APPLICATION NO. P22/S2932/LB

**APPLICATION TYPE** LISTED BLDG. CONSENT

SITE Wall between No. 104 & 105 High Street

**PROPOSAL** Creation of new opening at the first floor level

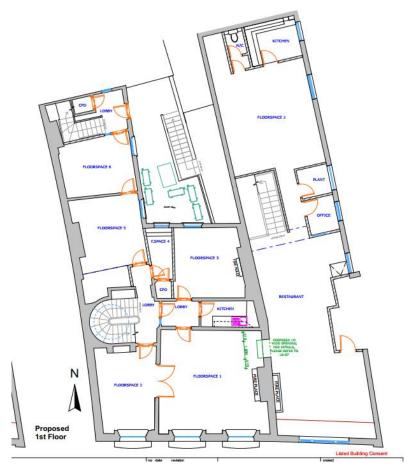
The proposal concerns the breaking through of an established historic party wall between Nos 104 and 105 High Street Thame. These are two separately listed buildings which have historically fulfilled different town functions.

The first floor of 105 is currently occupied by the noted cafe/restaurant who wish to extend their seating area through to the first floor of 104. This would involve the demolition of a small area of primary fabric in a solid brick masonry party wall. It should also be noted that part of the skirting to the front room of 104 would be lost.

While the brickwork itself does not possess high historical value, the configuration of rooms of each property, and especially what appears to be the historical uninterrupted configuration and decorative scheme of the piano nobile (first floor front room) of 104 is of high historical significance.

The interruption of this configuration by joining these two buildings at any level through the party wall would result in a loss of distinction between the two properties and be an unnecessary and confusing alteration to their established plan form. This would amount to a substantial level of harm to both listed buildings. I must therefore recommend that this application for development be refused.

After visiting the site and discussing the proposal with the Conservation and Design Team I am compelled to deliver a response consistent with my previous assessment of less than substantial harm. The proposed doorway removes the historic separation of two listed buildings of different ages and phases of period construction. These buildings were never intended to intercommunicate, and the proposed doorway is a clear breach of this intention, altering the design of the plan form which historically focuses on vertical integration and not horizontal integration.

The proposed doorway harms the high aesthetic significance of the principle front room of No 104 by removing the symmetry of the east wall. The symmetry of the chimney breast in the principal room was of key importance to period architects and the proposed doorway interrupts this symmetry. Further to this, the front rooms of the first floor represent what are likely one of the best-

preserved examples of merchant class 19<sup>th</sup> century first floor town living in Thame, meaning any interruption to the symmetry and decorative scheme here would be especially damaging.

I consider therefore that the proposed works amount to a medium to high level of less than substantial harm.

That said, this level of harm may be reduced slightly by relocating the proposed doorway to Floorspace 3, as identified in drawing LB-04 of the submitted plans. This would avoid any interruption to the well preserved decorative and plan form of the front rooms. The relocation of the doorway out of the front room would reduce the level of harm to No 104 by preserving the character of the higher status front rooms. In my opinion, any proposal to connect these two separate listed buildings horizontally will erode their historic and architectural interest, resulting in some level of less-than-substantial harm to their significance which will need to be weighed by potential public benefits by the Case Officer.

1. The proposed opening between number 104 High Street and number 105 High Street, to allow for the extension of seating for 'Cafe Gloria', would result in removal of primary historic fabric and alteration to the design of the plan form. The proposal would result in a medium to high level of less than substantial harm to the significance of both designated Grade II listed buildings. The public benefits of extending the seating of the existing cafe do not outweigh the identified harm to the significance of the designated heritage asset. As such, the proposal is contrary to policies ENV6 and ENV7of the South Oxfordshire Local Plan 2035 and paragraph 202 of the National Planning Policy Framework.
